RFP-CMIP21201804

Amendment No. 1: To the Tender Documents

Fabrication Services for *Refuge Canada* travelling exhibition

Amendment Date: October 2, 2018

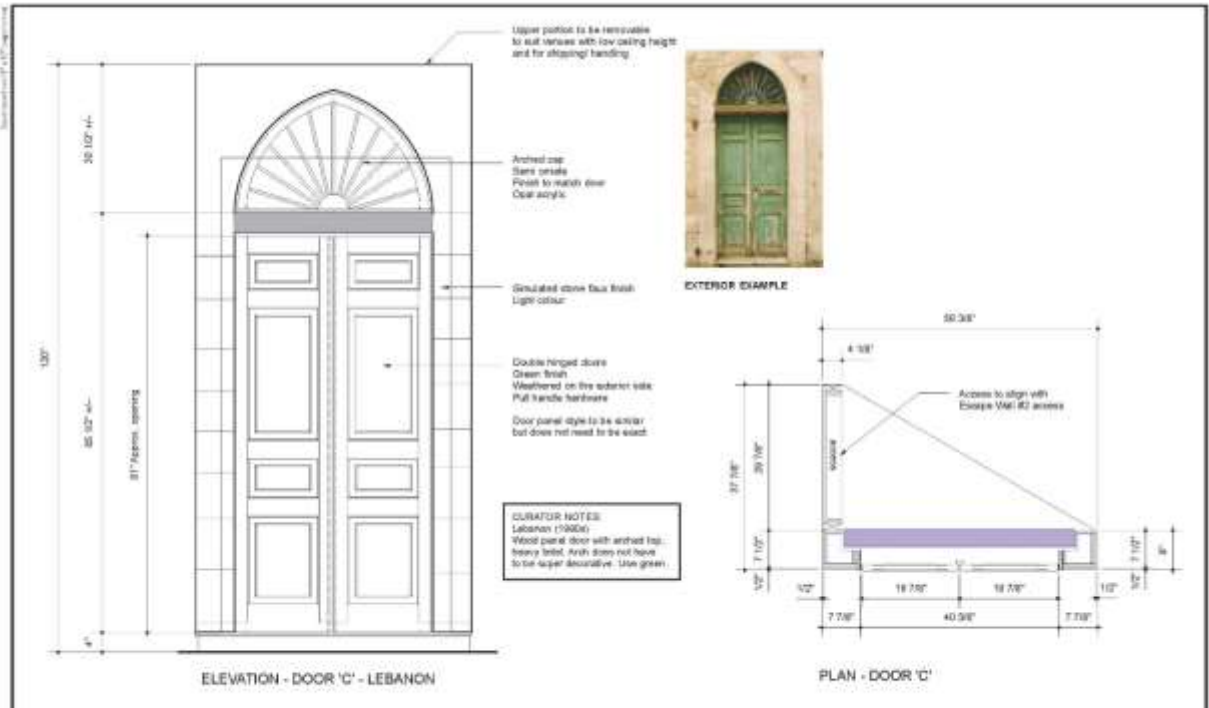
6) F4 – Fear Door (Section 2.2) – I would like to know if the existing fear door is fabricated in one piece?

Yes, the door and frame are mounted together. As shown on page 11 of Appendix A, the door is an L-shaped single unit with the door, frame and light box attached. The light box fabric is removable for transport.

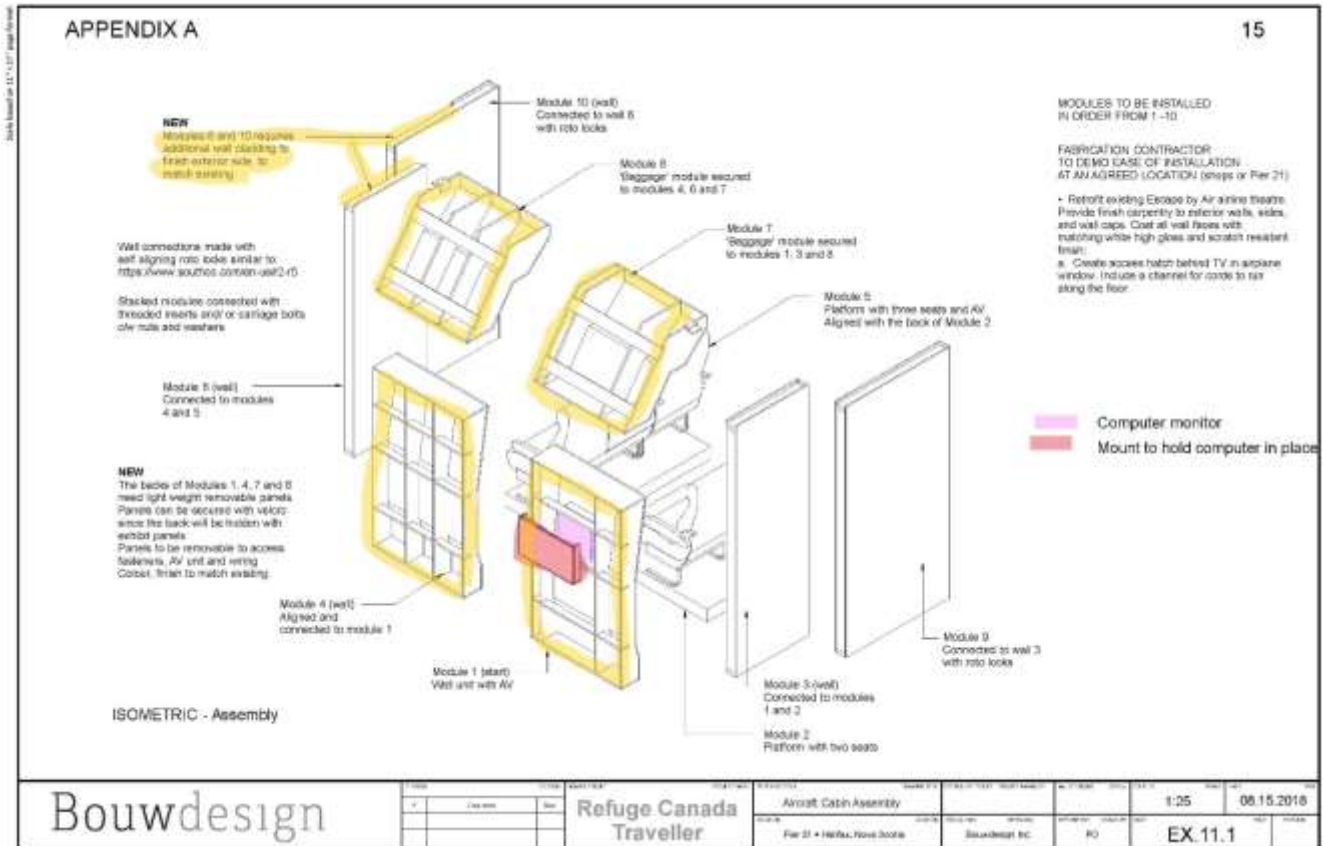
7) F6 – Escape by Air (Section 2.3.3) – Can we get pictures of exterior walls existing condition? Also, how is the existing TV and media player mounted currently?

Yes. The exterior walls of module 1, 4, 6, 7, 8, and 10 are unfinished plywood and MDF. Please refer to page 15 of Appendix A for the highlighted window panel (where existing tv is mounted) and drawing of the unfinished exterior wall.

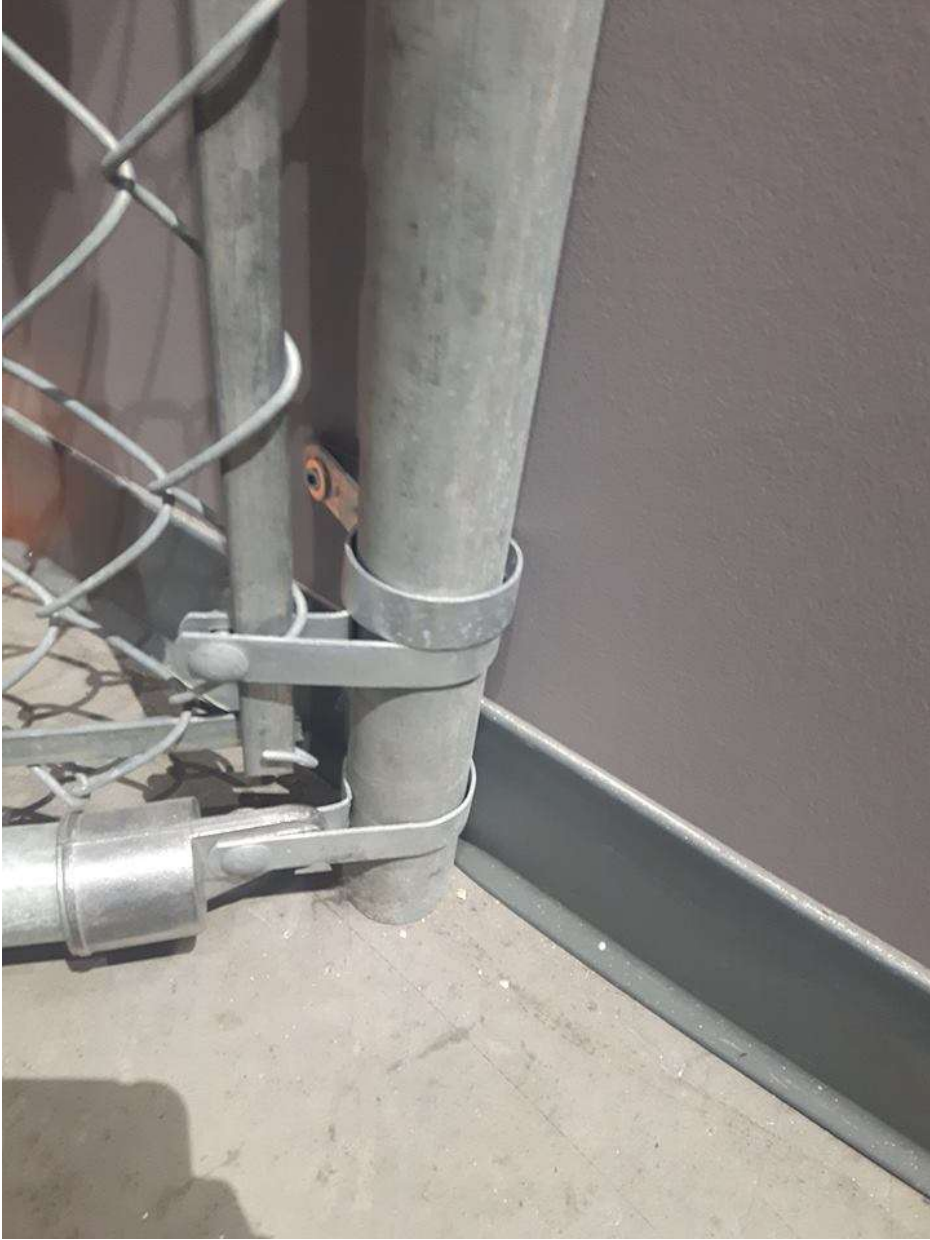
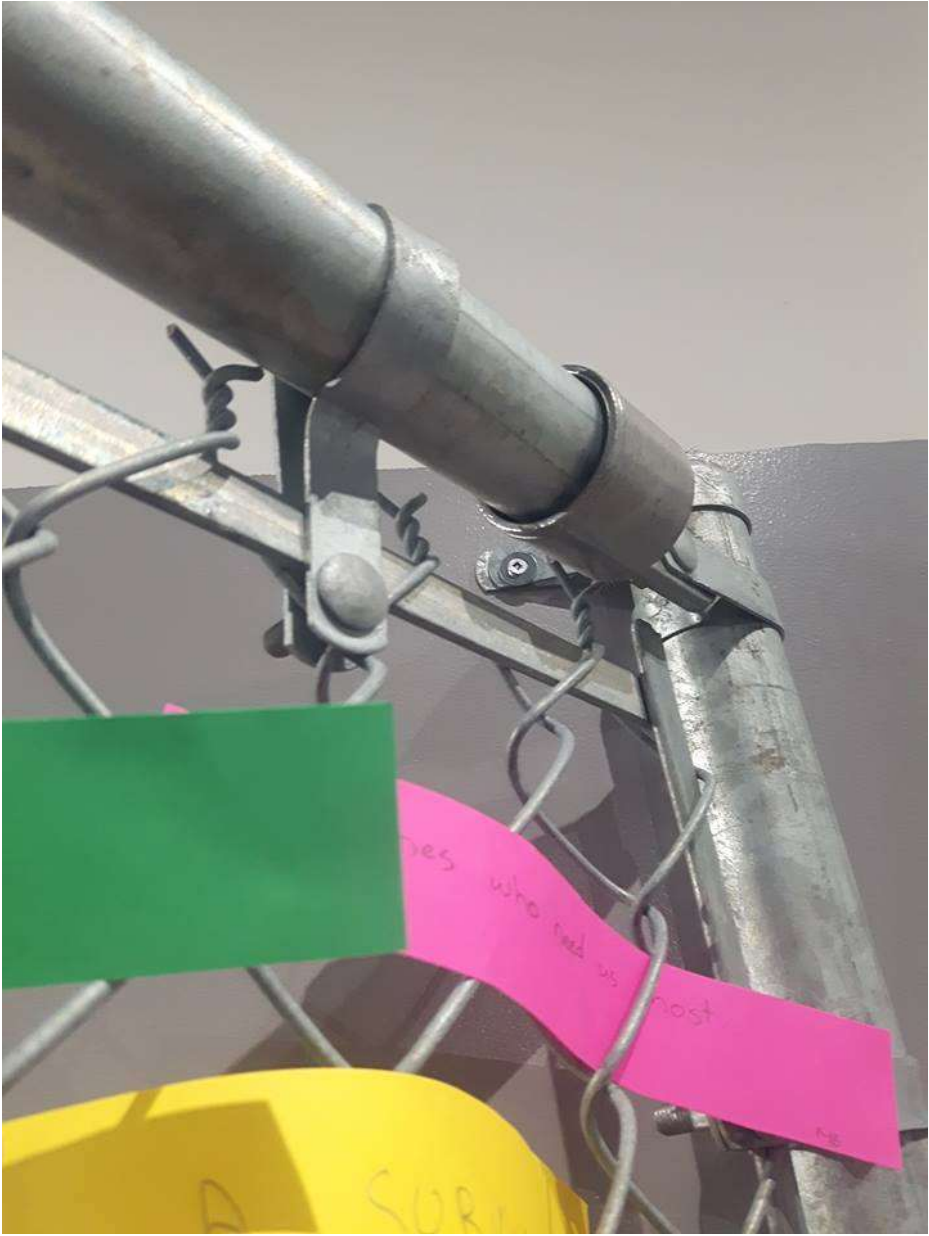
- 8) F9 – Chain Link Fence (Section 4.1.1) – How does the chain link fence stands currently? Also, how is the existing shelf mounted currently? Will the leg supports be used for the existing shelf after retrofit?

The chain link wall currently stands upright, mounted to the vertical fence posts and secured to the wall with brackets. The existing shelf is mounted with brackets attached to the chain link fence by bolts anchored to square plates and supported by vertical legs. The leg supports will be used for the existing shelf after retrofit, please refer to page 19 in Appendix A.
